CITY OF West Linn

STAFF REPORT FOR THE PLANNING COMMISSION

FILE NUMBER: SUB-17-01
HEARING DATE: May 17, 2017
REQUEST: 6-lot Subdivision at 4096 Cornwall Street

CHART I

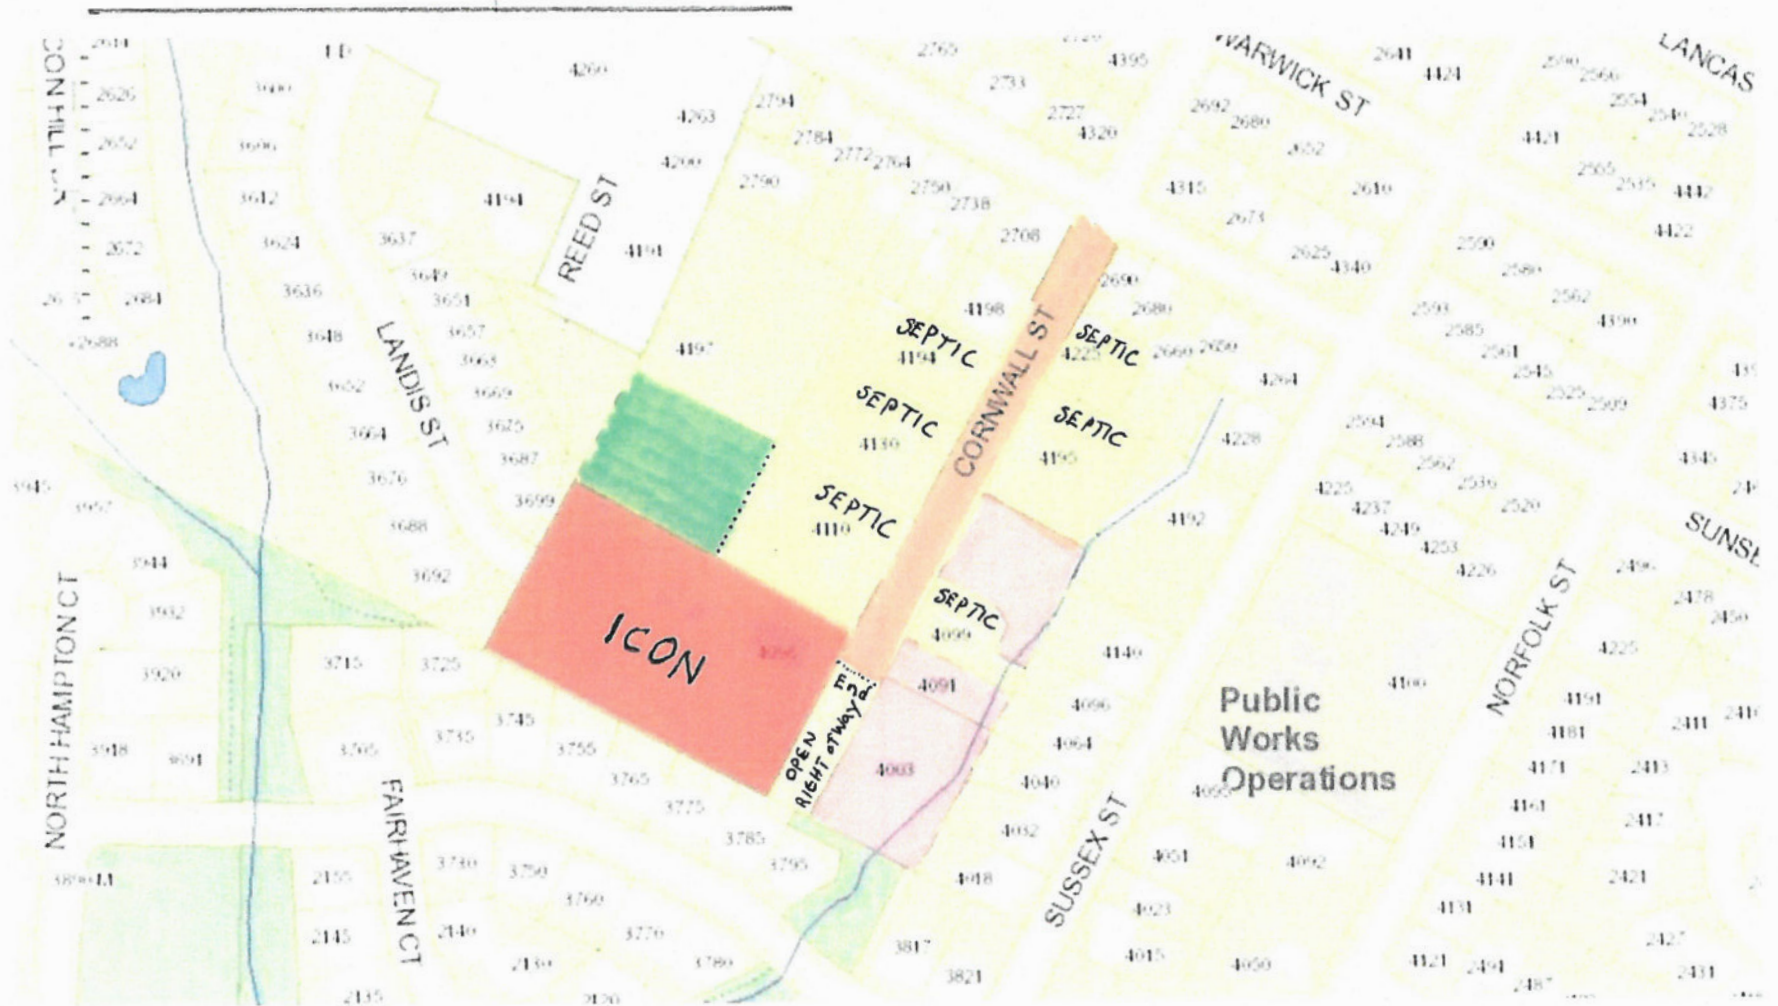
- undeveloped - Pedracini
- undeveloped - Clark
- septic systems
- extent of lower Cornwall St.
- ICON Willow Ridge
